Proposal for a draft Supplement to the 01 series of amendments to Regulation No. 55: (Uniform provisions concerning the approval of mechanical coupling components of combinations of vehicles)

A) PROPOSAL for add-on of a further strength test procedure for coupling balls and towing brackets class A50-X – modifications in following clauses of the Regulation:

Figures A, B: Statically determined, figure C: Statically undetermined

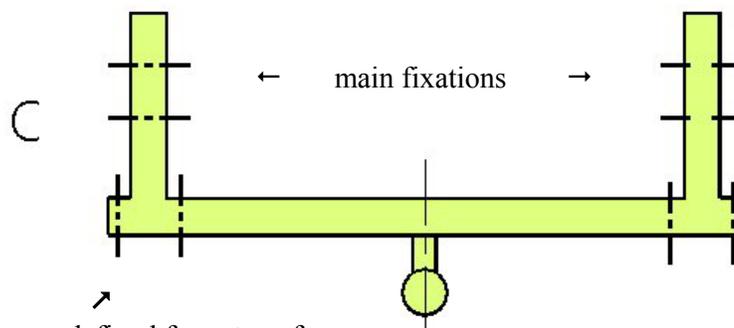
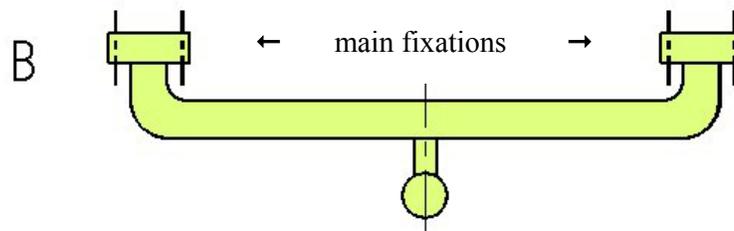
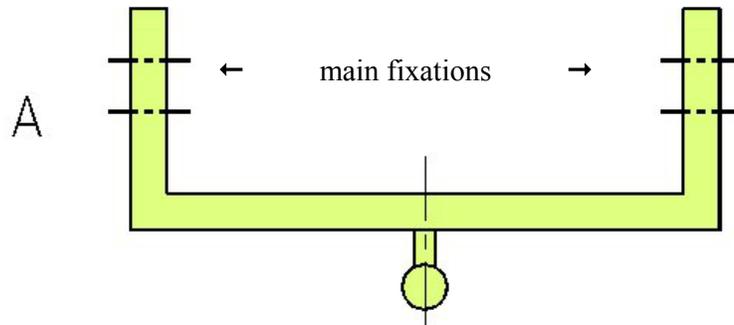
In case of well defined force transfer (see annex 7, appendix 2, e.g. figure A and B), the compliance of the fitting points of the coupling device has to be less than 2 mm (for the maximum forces F_x , F_y , F_z)

In case of undefined force transfer (see annex 7, appendix 2, e.g. figure C), the compliance of the main force transfer points has to be less than 2 mm (for the maximum forces F_x , F_y , F_z), the compliance of the auxiliary fitting points has to be similar to reality (vehicle body) or the auxiliary fitting points must not be attached during the test.

figure D1

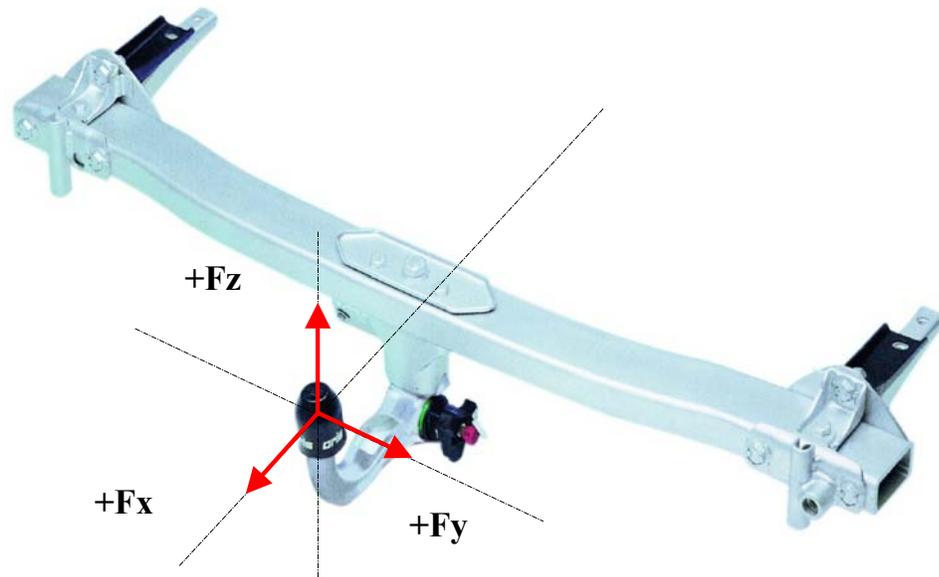
The variable load modules M1 - M3 do not include the static vertical support load. The permissible support load has to be added to the vertical loads Fz (channel 3, sign support load negative, see figures D1 and D2).
